County of Fairfax, Virginia

Re: Interpretation for RZ 2001-BR-022; Fairfax Gateway;
Tax Map 57-4 ((2)) 13, 16, 23, 24, 32, and 47: Peripheral Setbacks

RE: Fairfax Gateway
 Request for Letter of Interpretation (RZ 2001-BR-022)
 Project #003104.00

FAIRFAX GATEWAY
REZONING RZ 2001-BR-022
PDH-12
Plan #1847-SPV-001-G-1
REVIEWER: (N.A.A) Nicolas Antonopoulos
Oct. 6, 2009

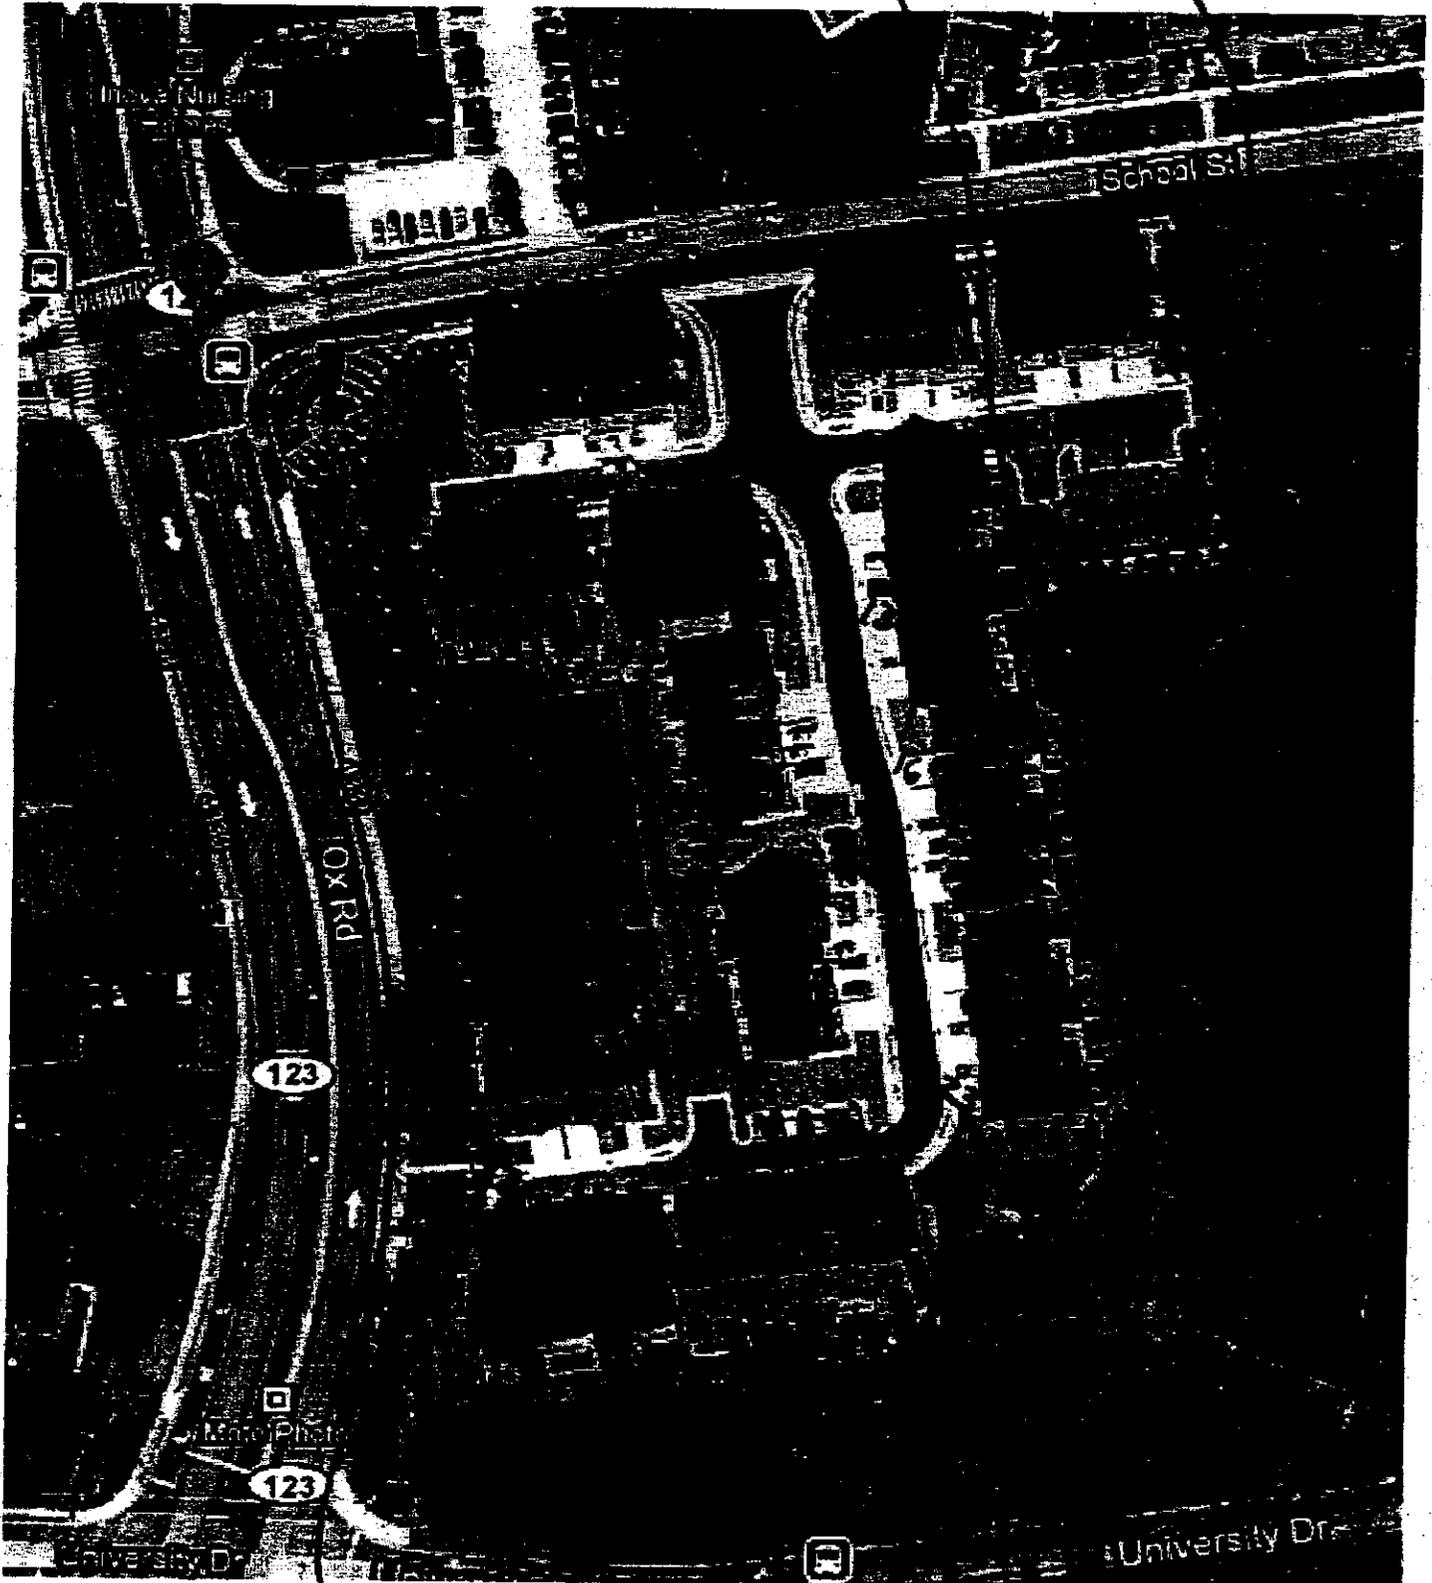
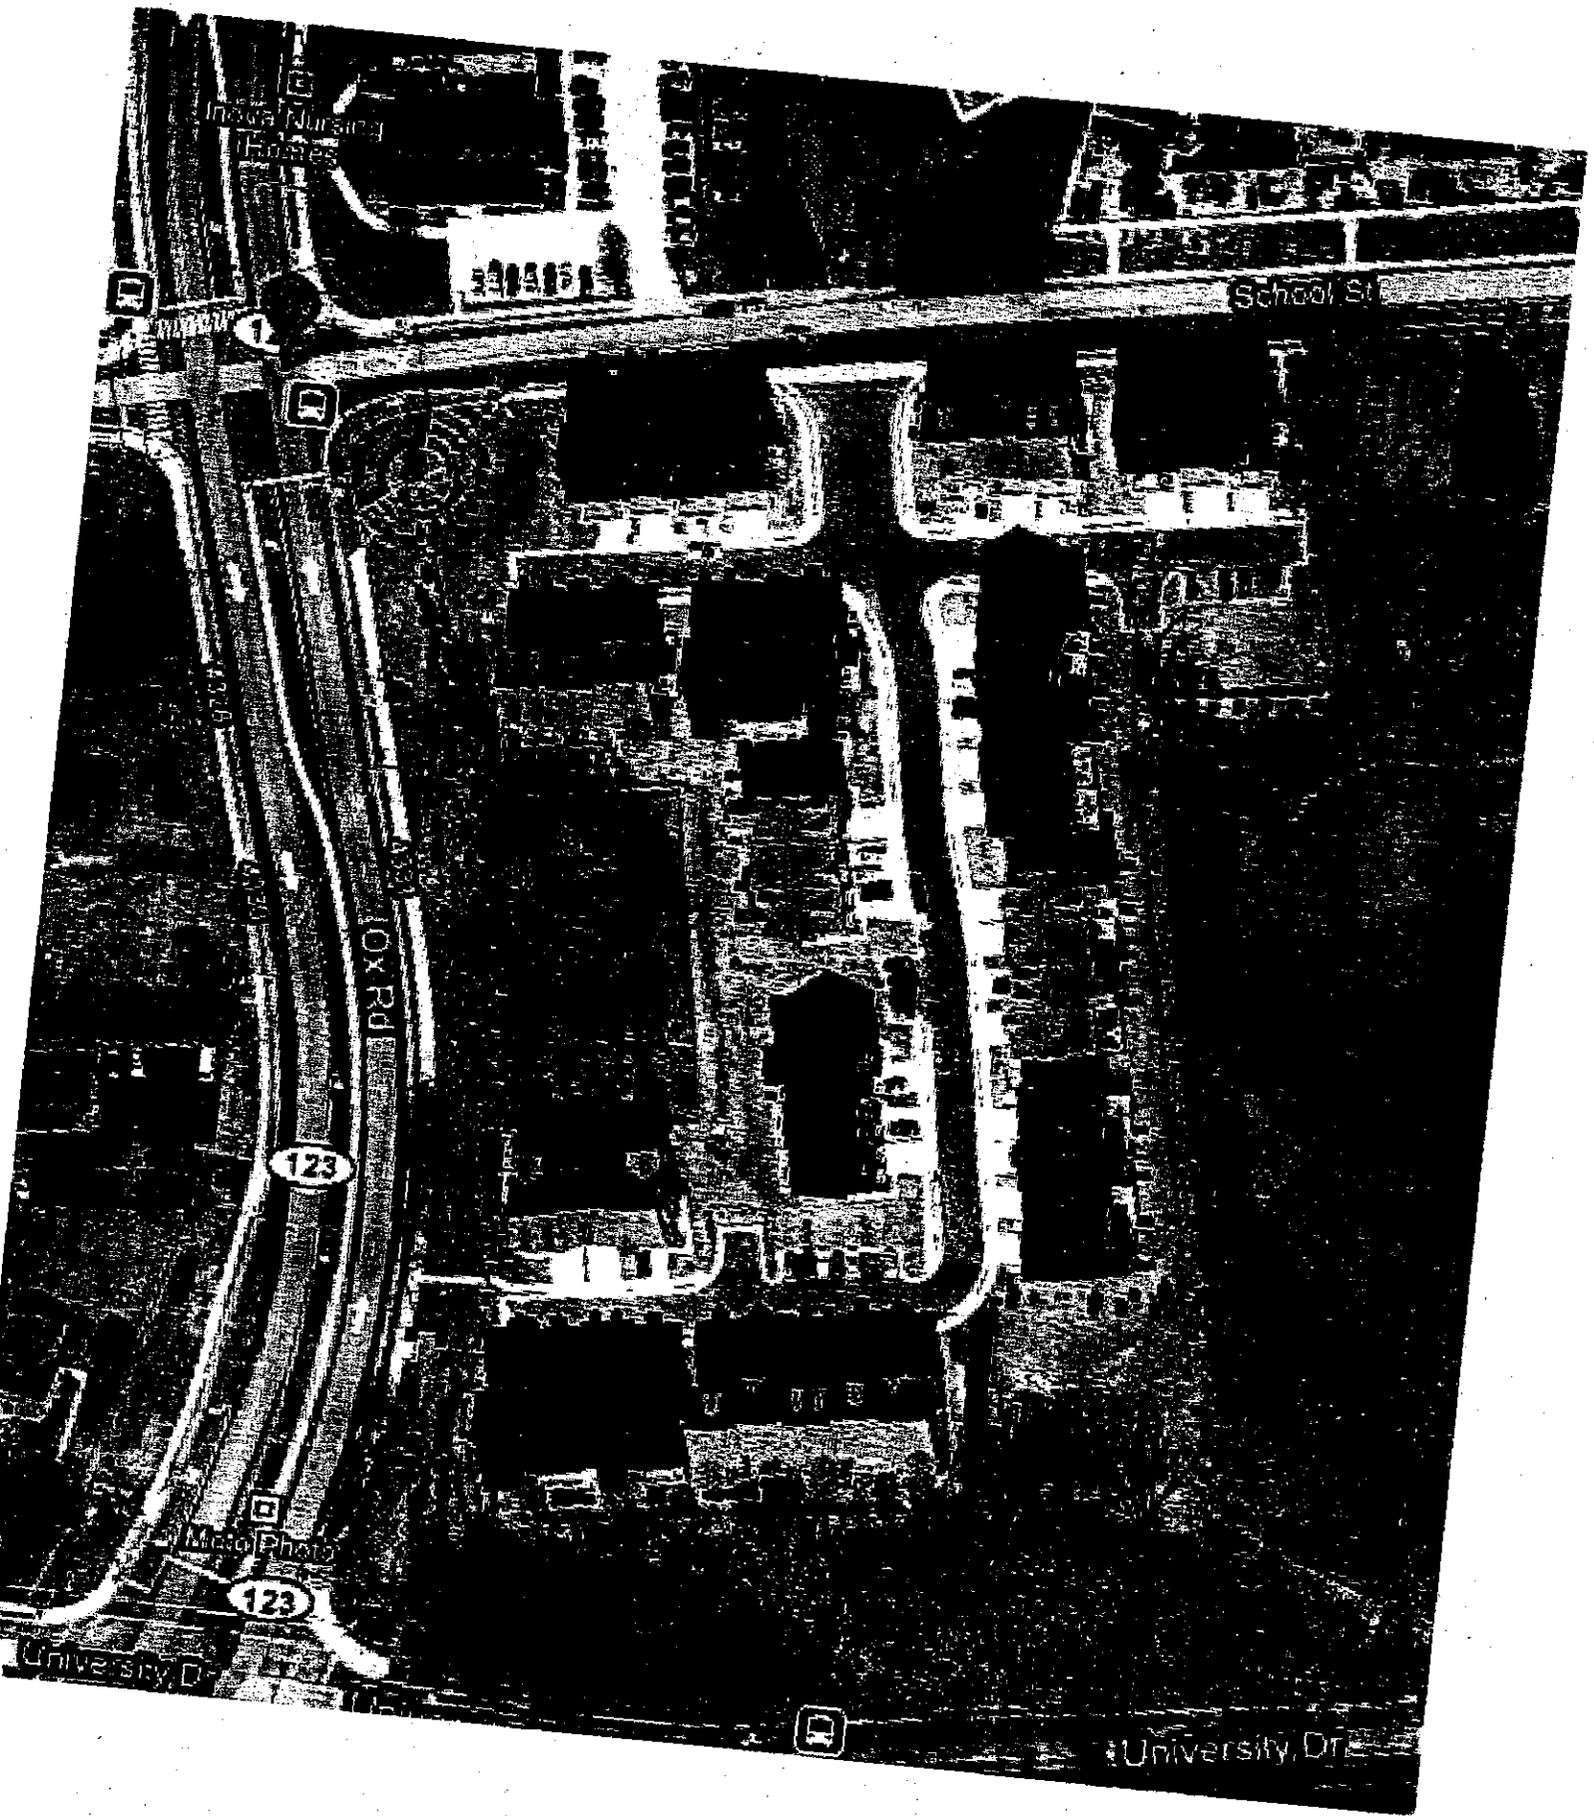
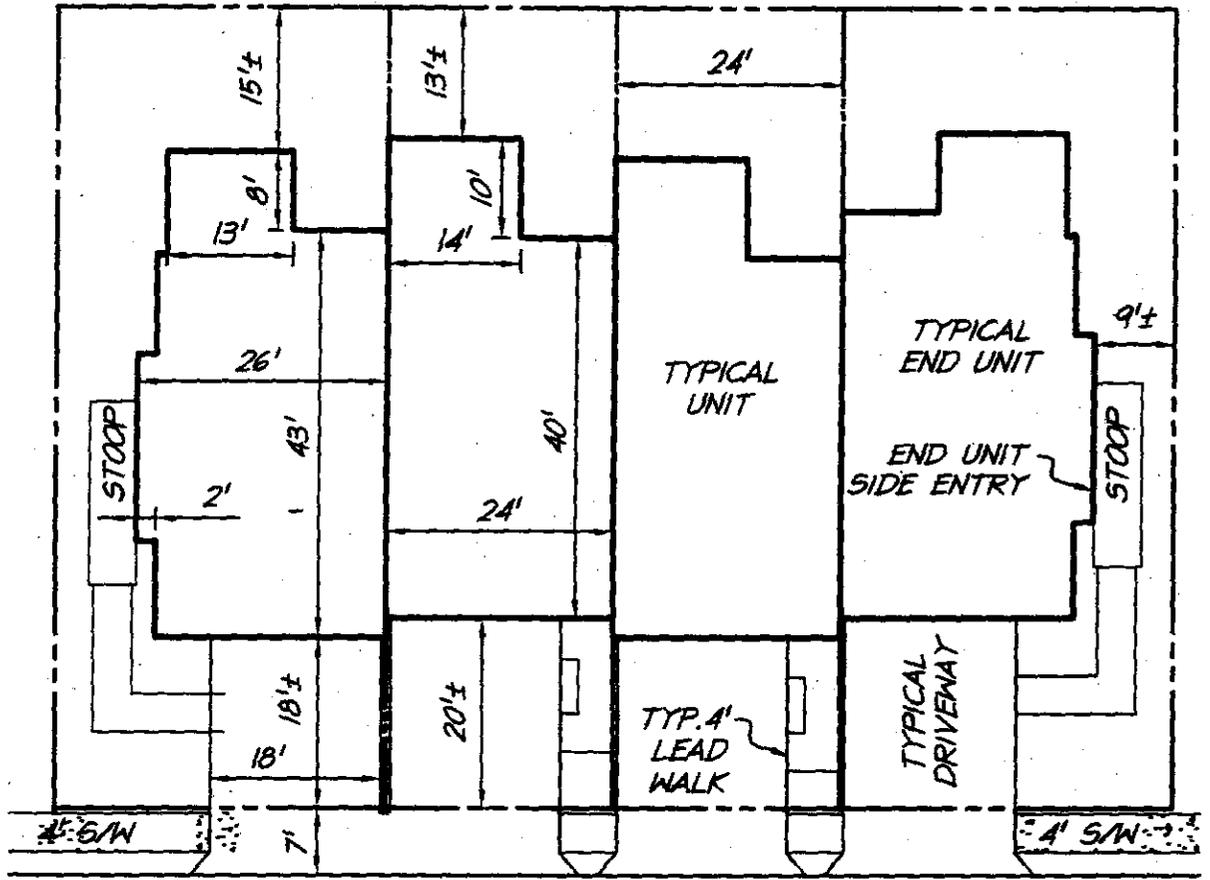
The perimeter setback of the site is in general conformance with the approved CDP/FDP with some minor differences. The perimeter setbacks for lots 23 (east), 24 (south), 32 (south), and 47 are more than the dimensioned perimeter setback as shown in the approved CDP/FDP. The perimeter setbacks for lots 23 (south), 24 (east), and 32 (west) are less than the approved by less than 5%. The perimeter setbacks for lots 13 and 16 are less than the approved by less than 10%. Please see table below for a lot-by-lot comparison of the perimeter setback from the approved CDP/FDP and the as-built conditions.

LOT	PERIMETER SETBACK		DIFF. (feet)	% DIFF.
	AS-BUILT	CDP/FDP		
	(feet)	(feet)		
13	27.4	30	(2.6)	-8.67%
16	22.1	24	(1.9)	-7.92%
23 (east)	30.0	28	2.0	-
23 (south)	124.4	125	(0.6)	-0.50%
24 (east)	133.5	134	(0.5)	-0.37%
24 (south)	22.5	22	0.5	-
32 (south)	22.9	21	1.9	-
32 (west)	39.4	40	(0.6)	-1.50%
47	66.3	65	1.3

I am enclosing a copy of the approved CDP/FDP site plan with as-built dimensions added in a box. I would appreciate your review and approval of this request as an interpretation of the CDP/FDP. If you have any questions regarding this request or require additional information please do not hesitate to contact me.

In your letter you indicate that minor changes to the peripheral setbacks for Lots 13, 16, 23, 24, 32 and 47 have occurred. While your request treats the peripheral setbacks separately, the proposed changes to several of the peripheral setbacks include and, in some cases, compensate for the modifications to the rear yards previously approved. The proposed changes and the previous modifications are summarized in the table below.

The proposed changes in the peripheral setbacks are as follows. Lot 13, which you have indicated would have a peripheral setback of 27.4 feet, or a decrease of 2.6 feet, actually would reflect an additional decrease of only 0.8 feet when the previous reduction in the rear yard is taken into account. The change in the peripheral setback for Lot 16 was reflected in the previous modification of the rear yard, and therefore, although reduced by 1.9 feet, would have no additional impact and offsets a large portion of the approved reduction in the rear yard. Lot 23 (on the east side) would have an increase of two feet in the peripheral setback which offsets the slight reduction in the rear yard and provides a net increase of 1.6 feet. The peripheral setback on Lot 23 (on the south) would be decreased by 0.6 feet. The peripheral setback on Lot 24 (on the east) would be decreased of 0.5 feet. Lot 24 (on the south) would have an increase of 0.5 feet in the peripheral setback, which offsets the reduction in the rear yard previously approved. Lot 32 (on

the south) would have an increase of 1.9 feet in the peripheral setback, which offsets the reduction of the rear yard previously approved. The peripheral setbacks on Lot 32 (on the west) would have a decrease of 0.6 feet and on Lot 47 an increase of 1.3 feet, respectively.

It is my determination that the revised peripheral setbacks, as shown on your submitted exhibit, are in substantial conformance with the proffers and the CDP/FDP. This determination has been made in my capacity as the duly authorized agent of the Zoning Administrator.

SETBACK EXHIBIT

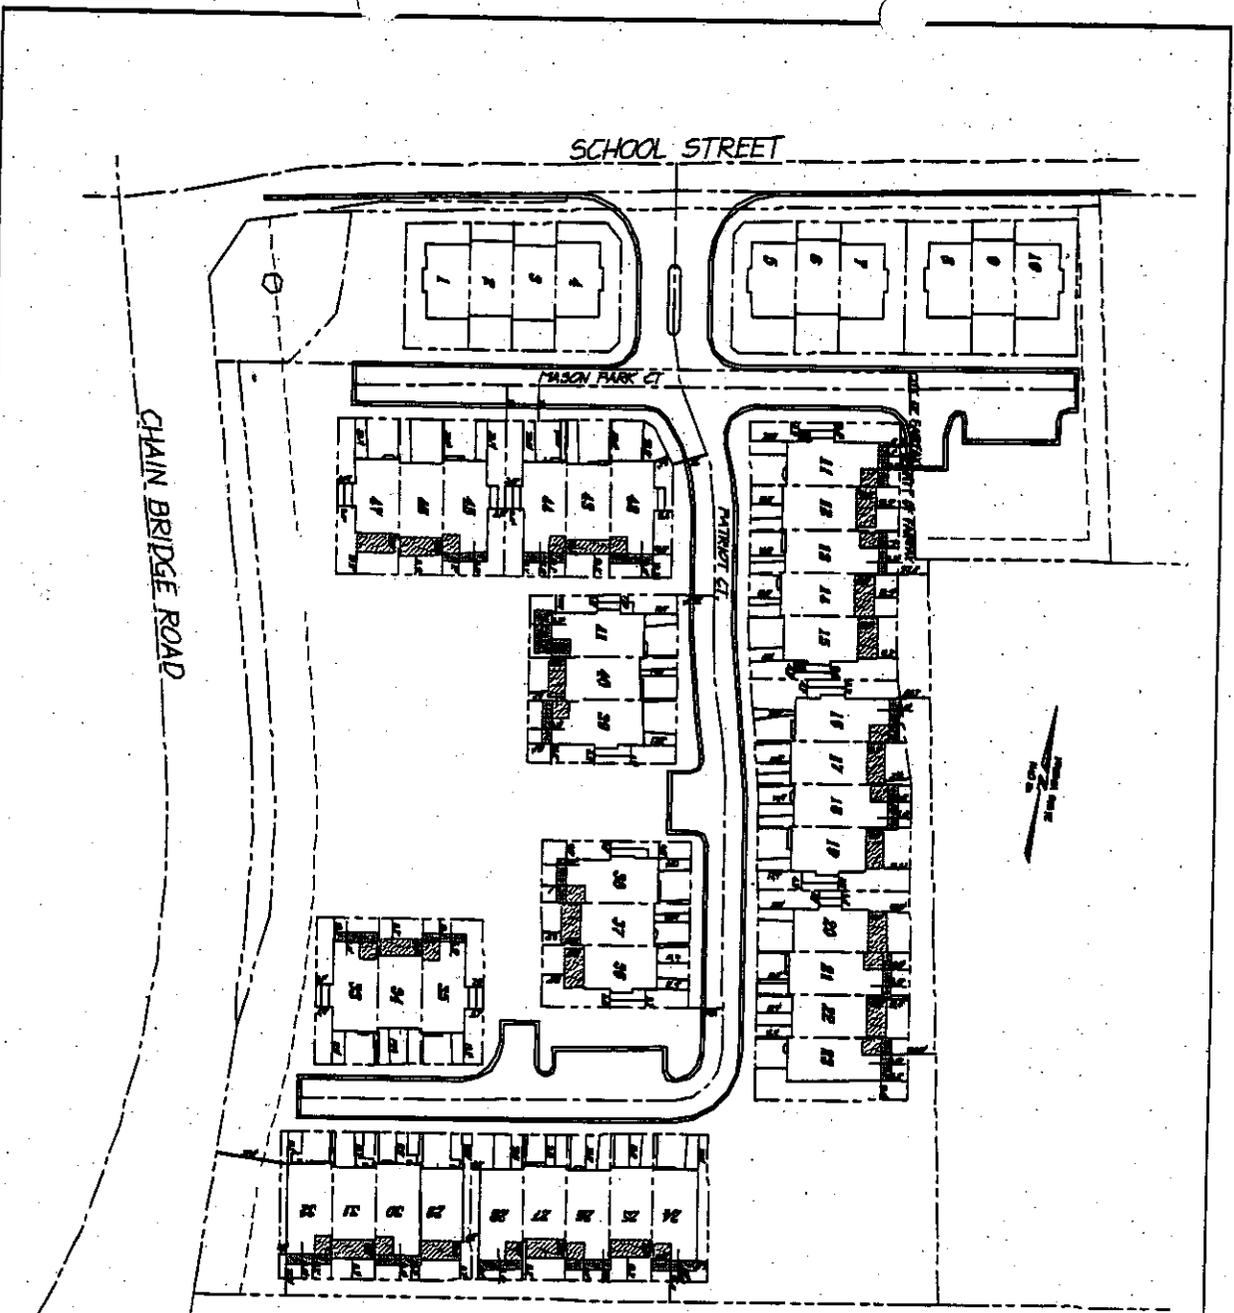
Relative to the specific issue at hand, the approved CDP/FDP has some conflicting information. The conflict appears on sheet 41 (as attached from the approved site plan) and on the site plan (sheet 39). The detail is entitled: "Unit Detail Fairfax County" drawn at a 20 scale and so noted. When you add the 15' rear dimension to the 51' house footprint (including 8' sunroom) and an 18' front yard, the lot would need to be 84' deep. On the site plan the lots scale only 82' in depth with rear setbacks of 12' and 14'. The unit detail is on sheet 3. The approved final site plans used the same lot geometry and unit sizes (see sheet 10), which also scale as a 12' and 14' rear setback. Hence we have a conflict between the typical section and the layout on the site plan sheet. There are also a few atypical lots as shown on the approved CDP/FDP which when scaled have significantly less rear yards (a minimum of 5' on lot 16) due to the angled rear lot line. All of the rear yards as constructed (please see attached "Setback Exhibit" by christopher consultants, dated 7/27/06) are similar in feel to the approved CDP/FDP and final site plans. The 13'+/- and 15'+/- can vary up to 1.9' less than those dimensions. However, when taken from the scaled dimensions on the approved CDP/FDP and final site plans they vary by less than 1'. Please see attached spreadsheet for a lot-by-lot comparison of the rear setback from the approved CDP/FDP and the as-built conditions. All of the rear yards do meet the minimum requirement of a 200 SF minimum privacy yard as well as the height and bulk plane of the overall site boundary (see attached exhibits).

In closing, we never intended the dimension on the sketch to be viewed as a minimum rear yard and are hopeful that given the inconsistencies within the approved CDP/FDP that this interpretation will be favorably viewed. I am enclosing a copy of the approved site plan which includes both the CDP/FDP (sheets 38-44) and the proffers (sheets 7, 7A, 8) for your convenient reference and as-built conditions showing the actual unit footprints which is in the spirit of the approved CDP/FDP and site plan. I would appreciate your review and approval of this request as an interpretation of the CDP/FDP. If you have any questions regarding this request or require additional information please do not hesitate to contact me.

The CDP/FDP contains an illustration of a typical single family attached dwelling lot, which includes yard dimensions and landscaping. The CDP/FDP also includes setbacks between the proposed dwelling units and the property line for the rezoning application. It is my understanding that all of the dwelling units meet the setback from the rezoning application property line shown on the CDP/FDP. I have reviewed the rear yards shown on the approved site plan and as summarized by the chart attached to your letter. It is my determination that the rear yards shown on Site Plan 1847-SP-01-2 are in substantial conformance with the proffered CDP/FDP for RZ 2001-BR-022. This determination has been made in my capacity as Senior Deputy Zoning Administrator.
